Roof Side Weatherstrip - Revised Installation

BO022-00

ROOF SIDE RAIL WEATHERSTRIP POOR RETENTION

'00 Celica

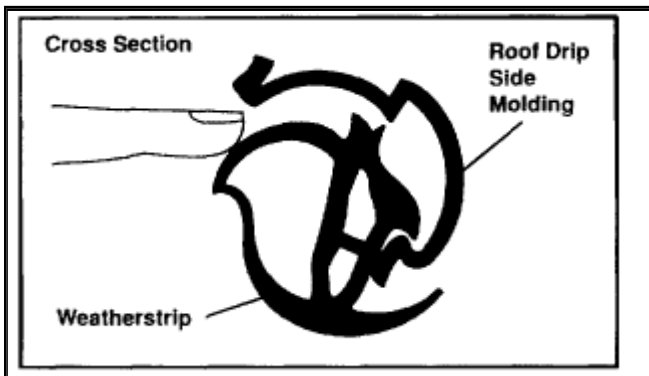
1. Check weatherstrip for deformation. Installation and/or damage.

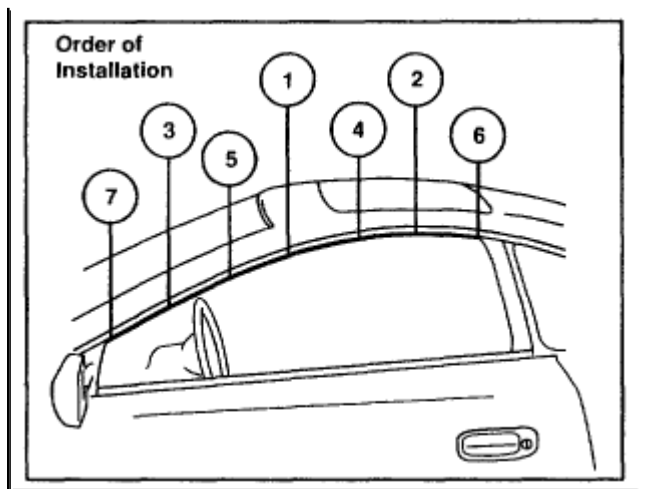
2. If the weatherstrip is in good condition, start by installing the weatherstrip in the No. 2 corner. If the weatherstrip is damaged, replace the weatherstrip.

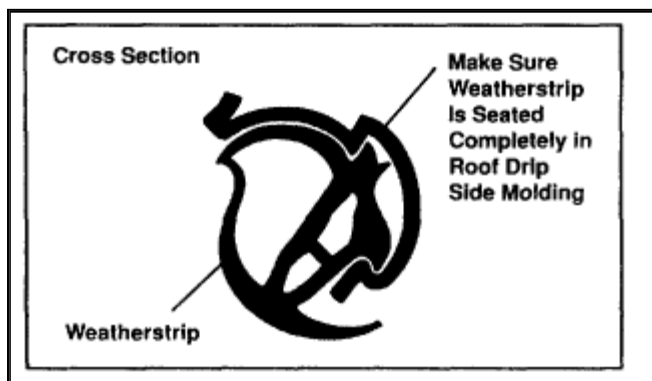
3. Hook the bottom edge of the weatherstrip into the roof drip side molding first. Then, using your fingers, install the top edge of the weatherstrip into the molding.

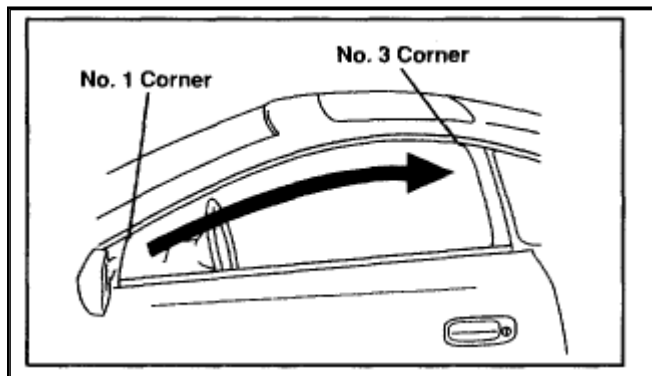
4. Continue to install the weatherstrip by hand in the order shown in the illustration.

5. Using finger pressure, press the length of the weatherstrip between the No. 1 and No. 3 corners to verify that the weatherstrip is seated completely in the roof drip side molding as shown in illustration.
